HUMBOLDT STATE UNIVERSITY

SUBJECT: IFB #PW20-1, Emergency Power Generators

Addendum #1

1.02 PROJECT: 1901734 HSU CRITICAL ELECTRICAL GENERATION

3.04 DRAWING MS-4.1 - PARTIAL SITE PLAN:

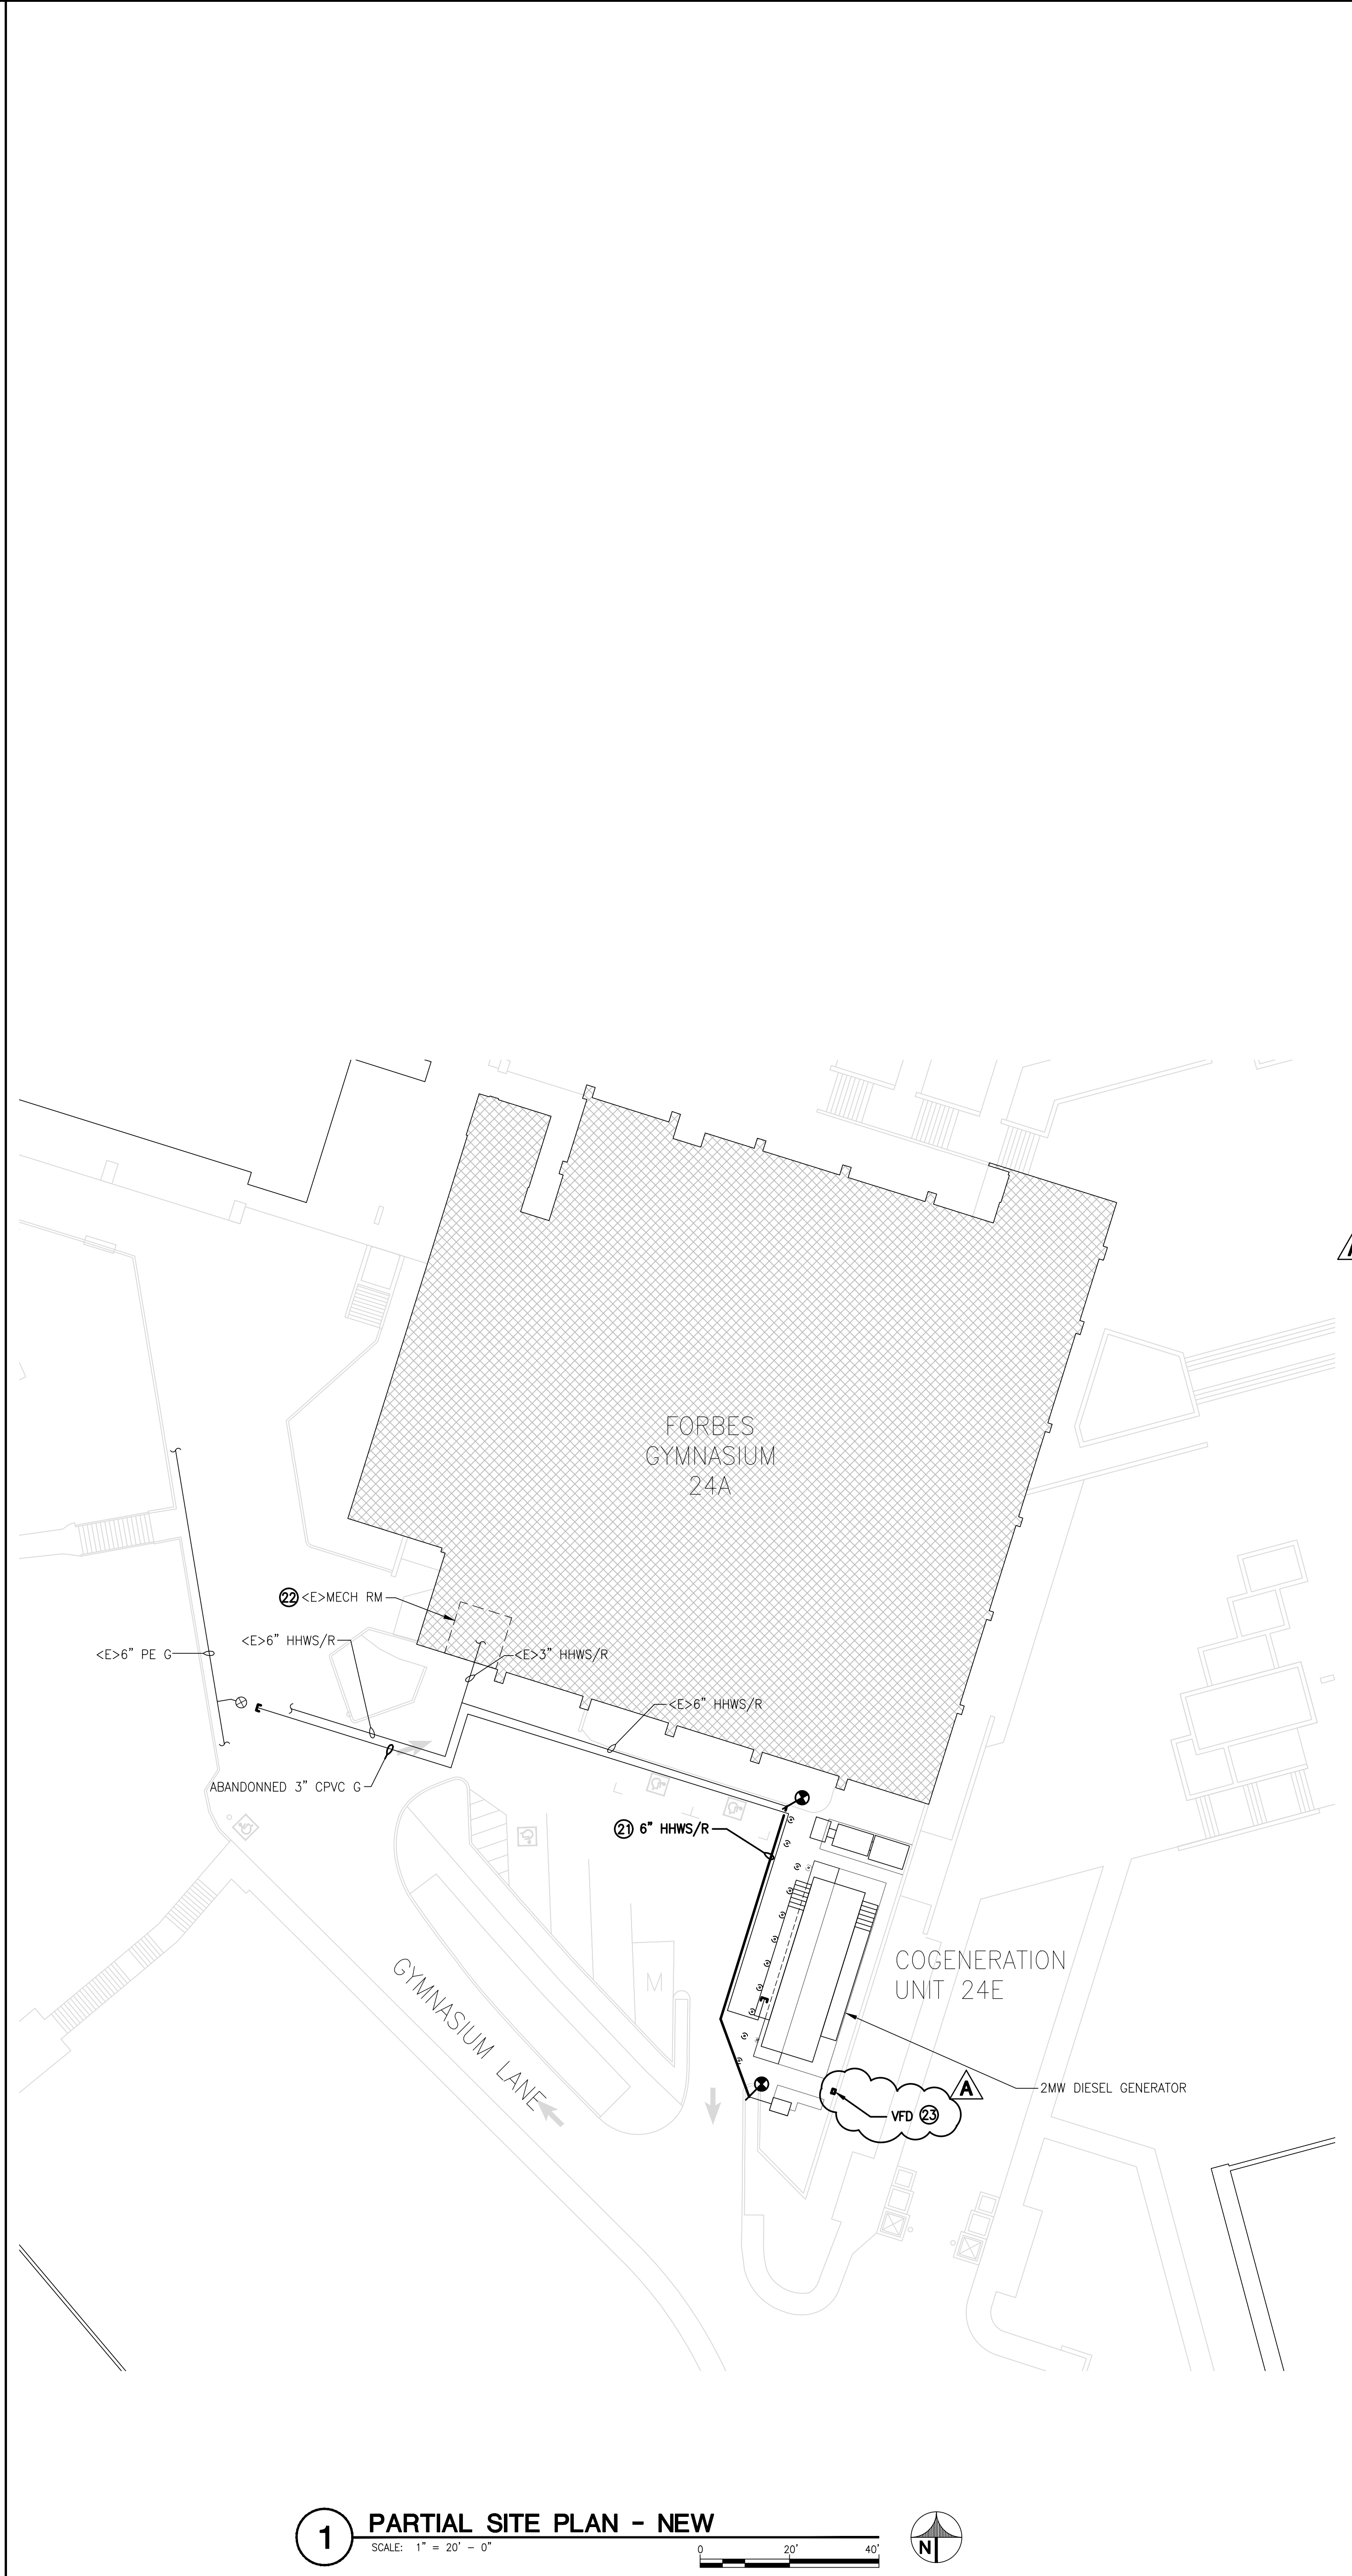
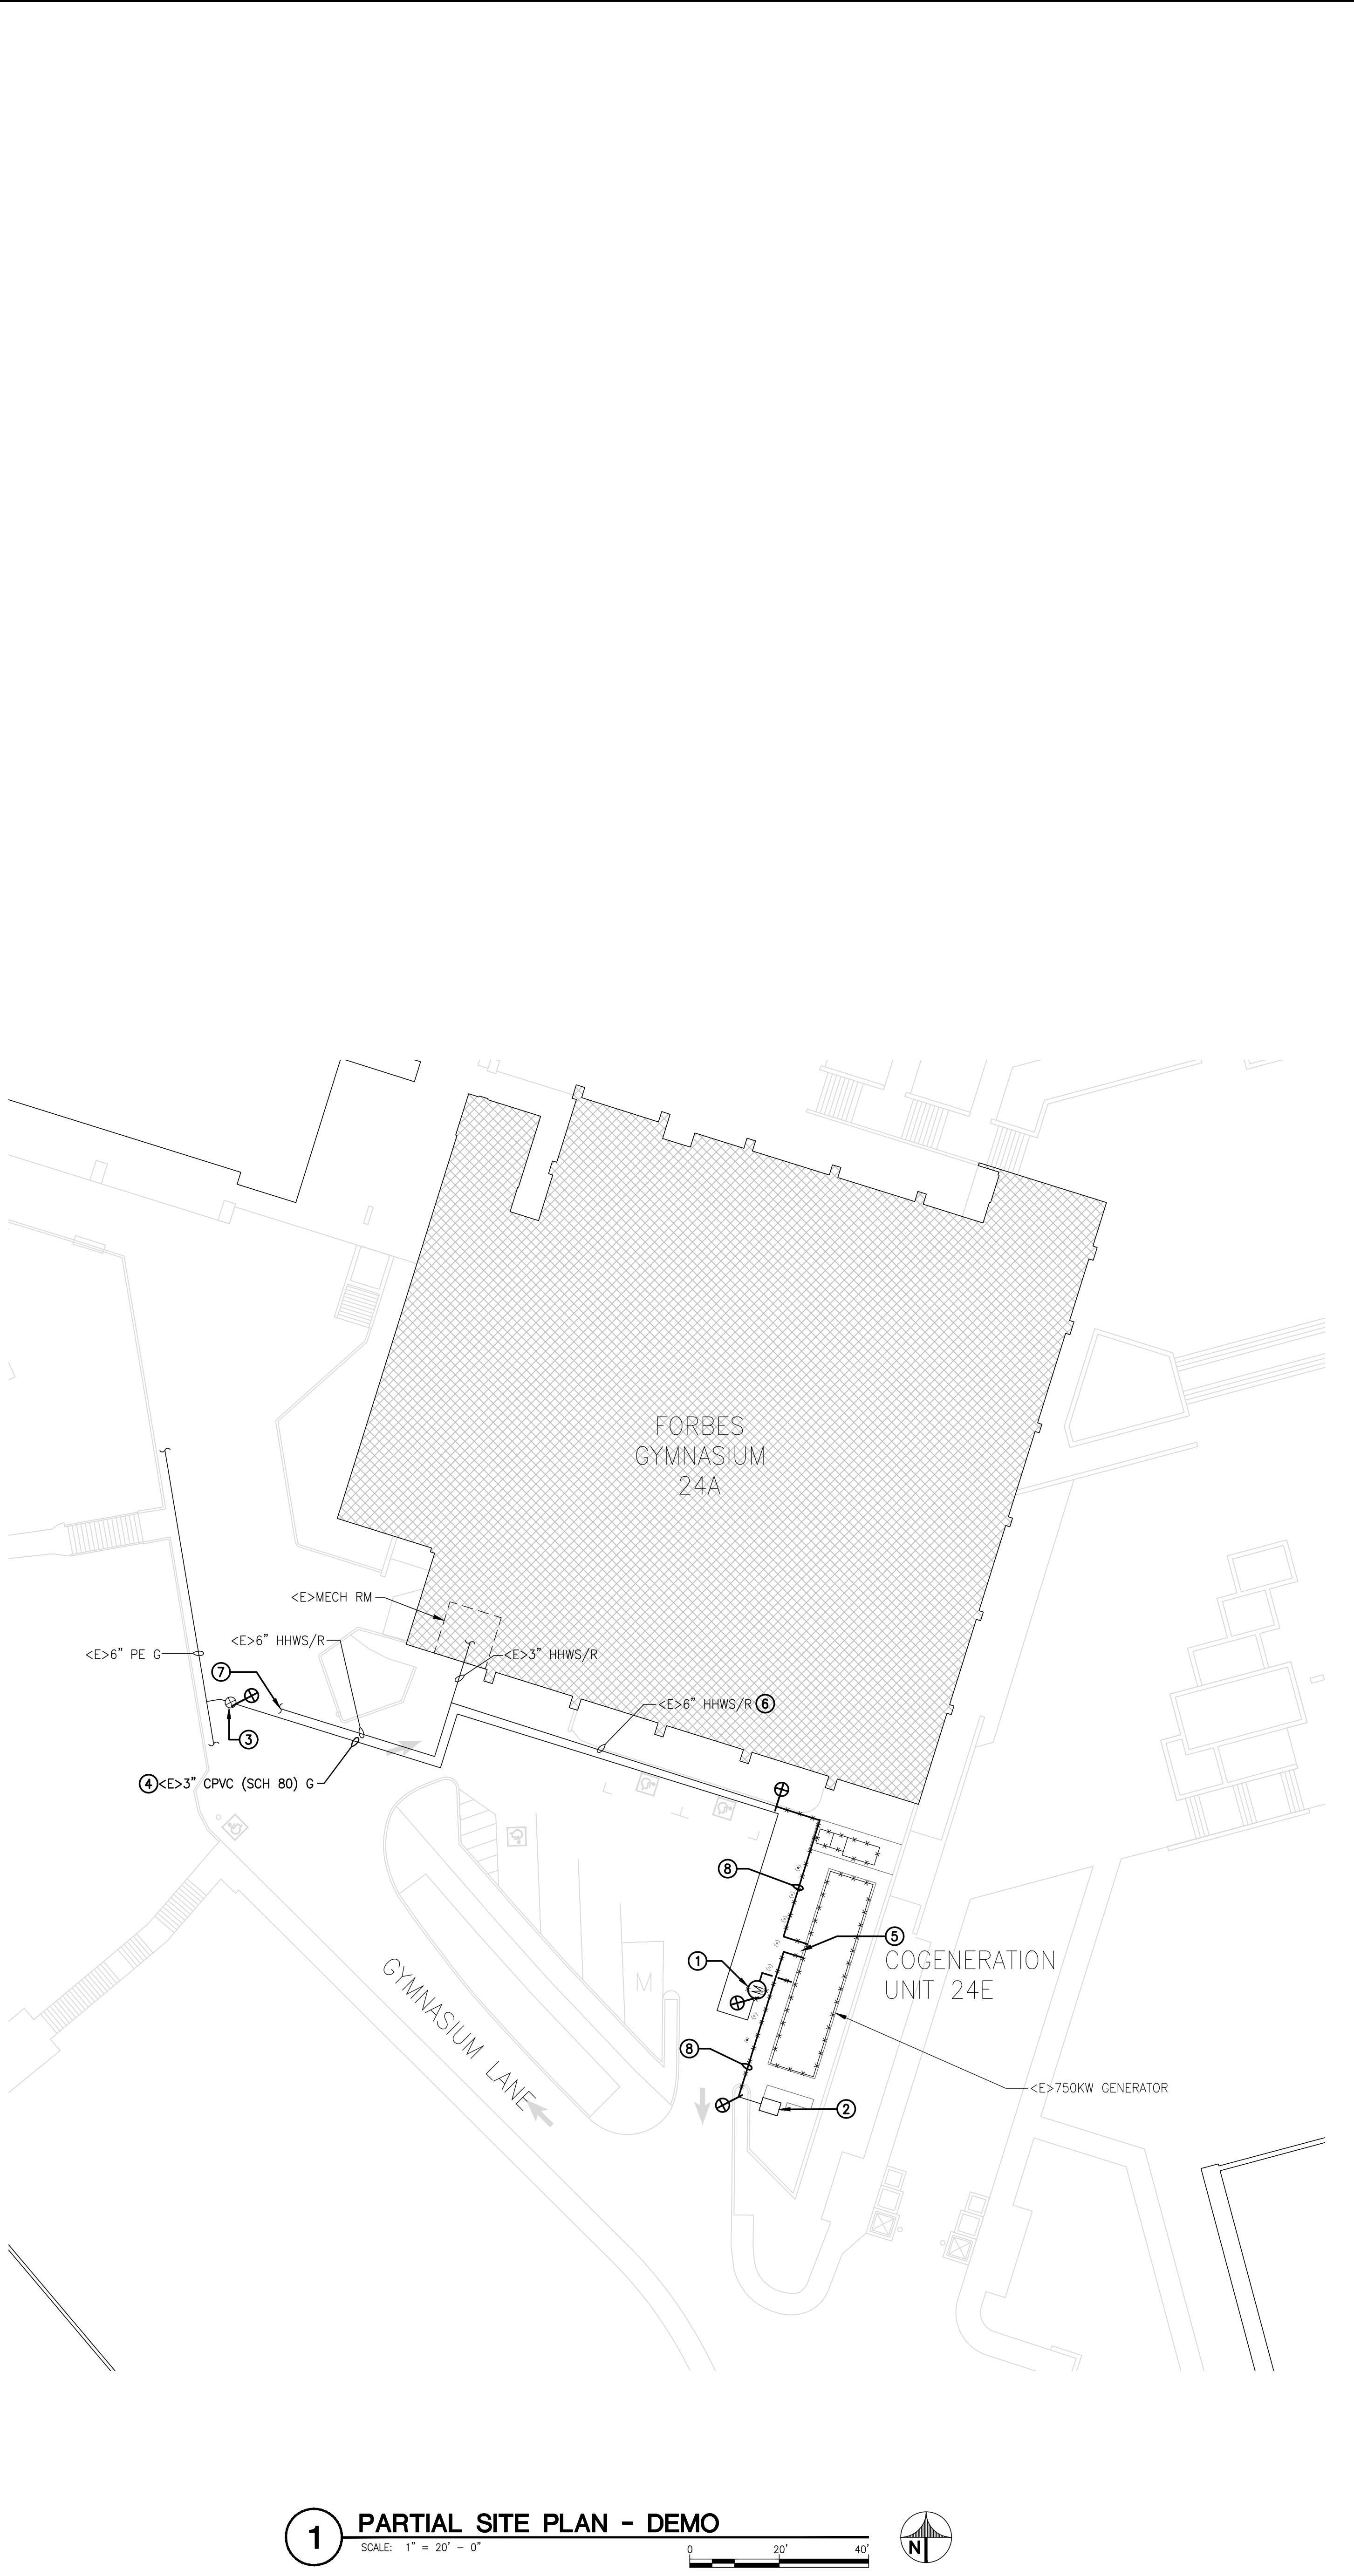
- A. Replace Sheet MS-4.1 in its entirety, reflecting the following modifications:
1. Provide new VFD for recirculation pump.

23. MECHANICAL CONTRACTOR SHALL PROVIDE NEW VFD FOR RECIRCULATION PUMP. PROVIDE IN NEMA4 ENCLOSURE. COORDINATE WITH ELECTRICAL CONTRACTOR FOR INSTALLATION. MATCH ELECTRICAL CHARACTERISTICS (VOLTAGE, PHASE, HERTZ & HP) OF <E> PUMP.
